PROJECT NAME: St. Louis Army Ammunition Plant

**RE: START Contract Region 7  
Request for Conflict of Interest (COI) Determination  
St. Louis Army Ammunition Plant, St. Louis, Missouri  
TDD Number: S07-9902-008**

SUBJECT: Draft Federal Facility Preliminary Assessment Review for St. Louis Army Ammunition Plant at 4800 Goodfellow Boulevard, St. Louis, Missouri.

SUBJECT: Final Federal Facility Preliminary Assessment Review for St. Louis Army Ammunition Plant at 4800 Goodfellow Boulevard, St. Louis, Missouri.

Figure 2: Site Map

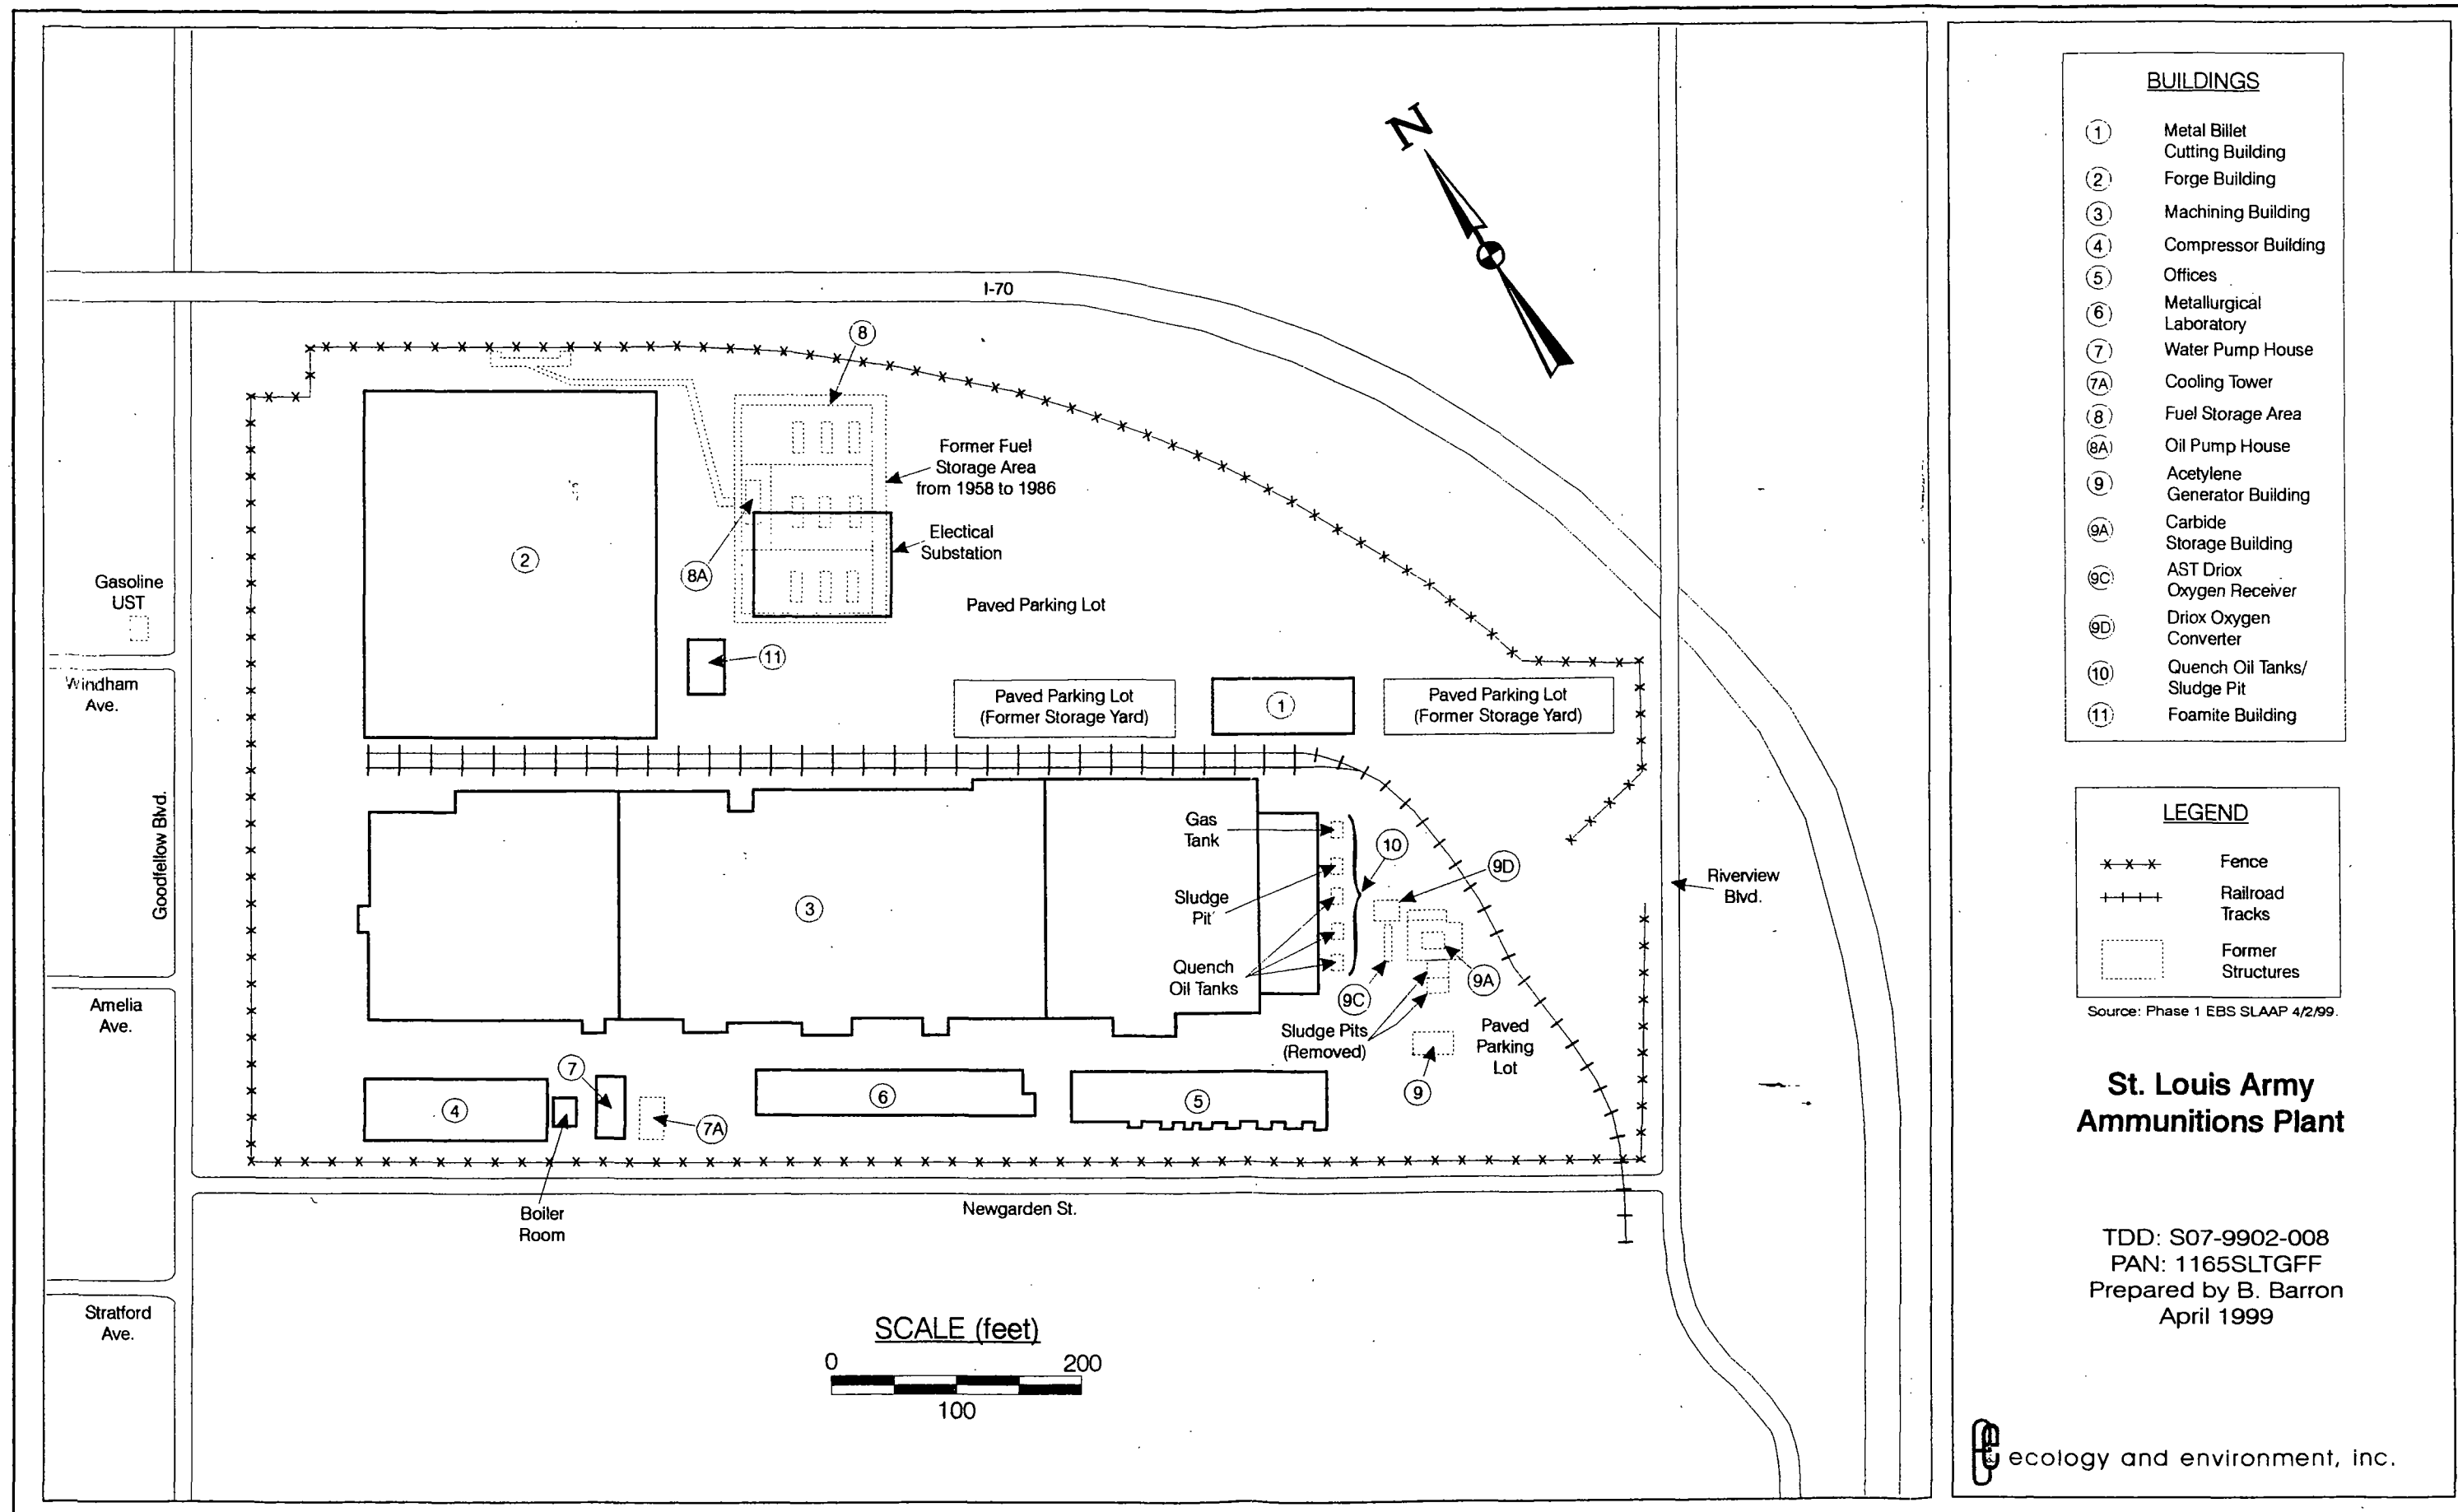
The SLAAP facility is currently inactive. This approximately 21-acre complex consisted of 11 buildings (Attachment 1: Figure 2, Site Map). Presently, the property has eight unoccupied buildings that were used to house the main operating processes of the SLAAP facility. Buildings/structures removed from the facility include #7A (cooling tower), #8 and #8A (fuel oil storage area and oil pump house), #9 and #9A (acetylene generator and calcium carbide storage buildings), as well as buildings #9C and #9D (AST diox oxygen receiver and diox oxygen convertor). Two underground storage tanks (USTs), one located east of the Machining Building (#3), and the other located southwest of the Forge Building (#2) have also been removed. In addition, three quench oil tanks and a sludge pit have been removed from Building #10 and two former billet storage yards adjacent to Building #1 are now paved parking lots. For the locations of the former buildings/structures, see Attachment 1, Figure 2.

Figure 2: Site Map

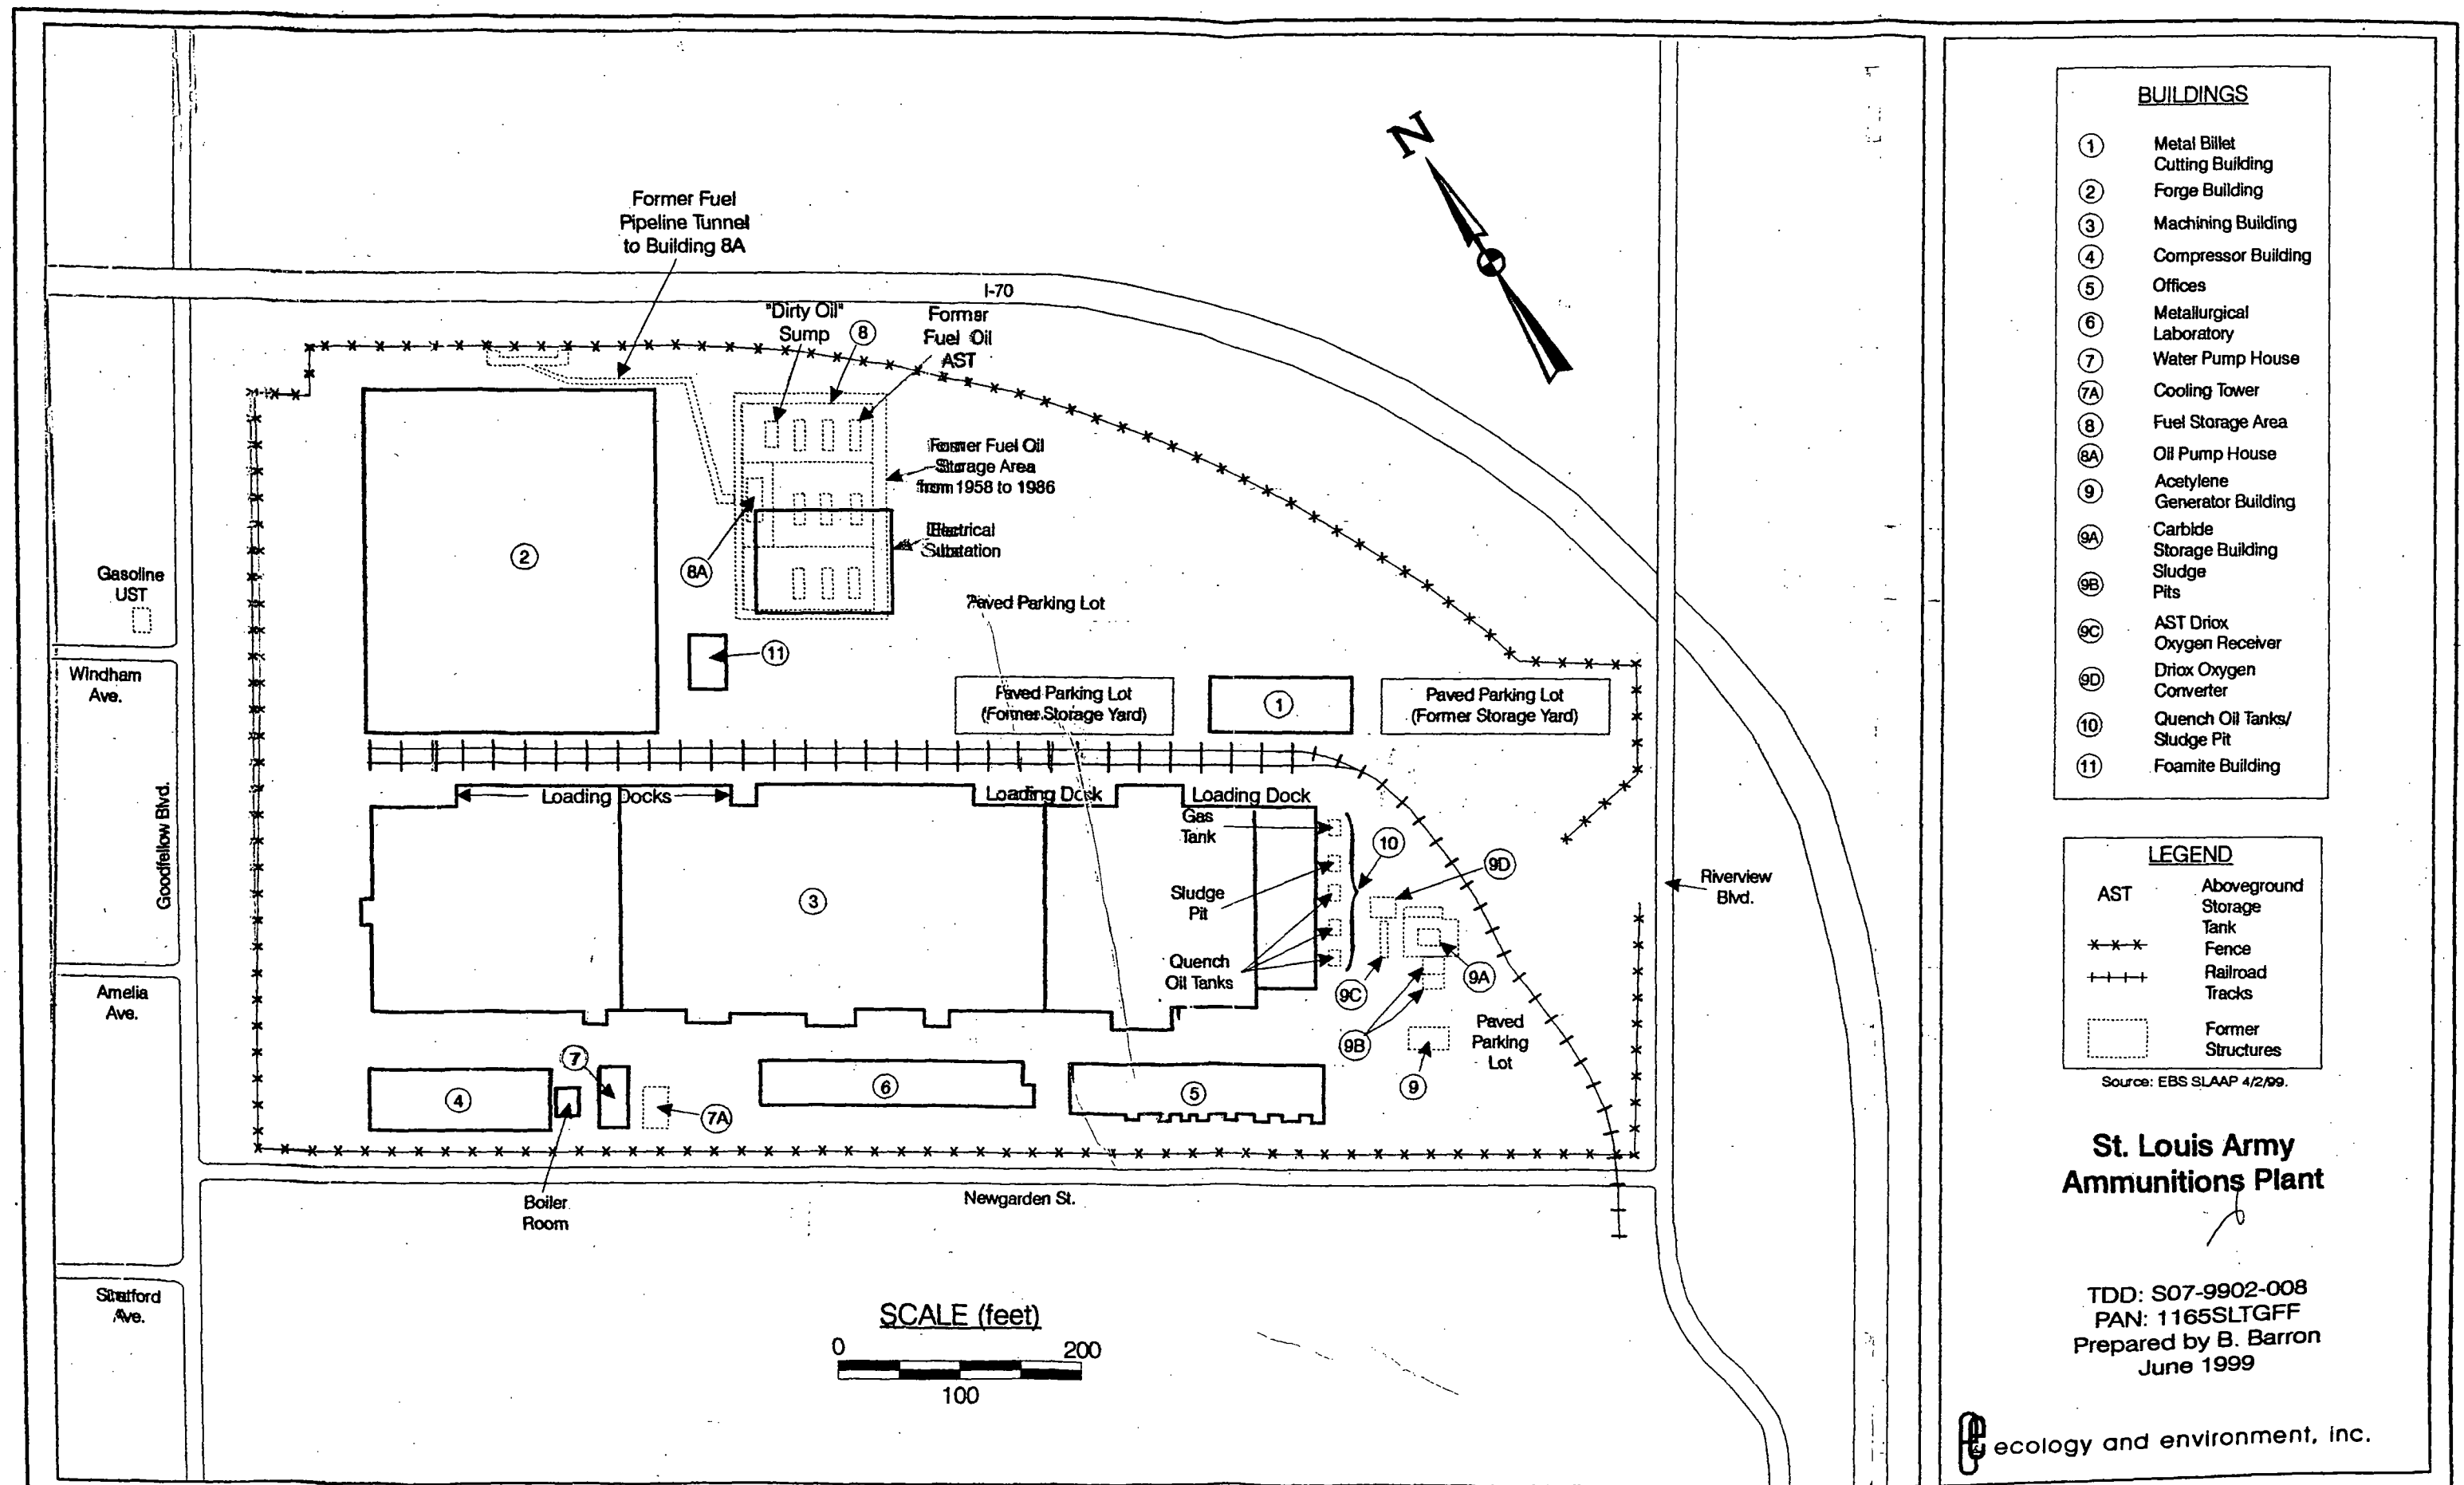
The SLAAP facility is currently inactive. This approximately 21-acre complex consisted of 11 buildings (Attachment 1: Figure 2, Site Map). Presently, the property has eight unoccupied buildings that were used to house the main operating processes of the SLAAP facility. Buildings/structures removed from the facility include #7A (cooling tower), #8 and #8A (fuel oil storage area and oil pump house), #9 and #9A (acetylene generator and calcium carbide storage buildings), #9B (sludge pits), as well as buildings #9C and #9D (AST diox oxygen receiver and diox oxygen convertor). Two underground storage tanks (USTs), one located east of the Machining Building (#3), and the other located southwest of the Forge Building (#2) have also been removed. In addition, three quench oil tanks and a sludge pit have been removed from Building #10 and two former billet storage yards adjacent to Building #1 are now

paved parking lots. For the locations of the former and current buildings/structures, see Attachment 1, Figure 2.
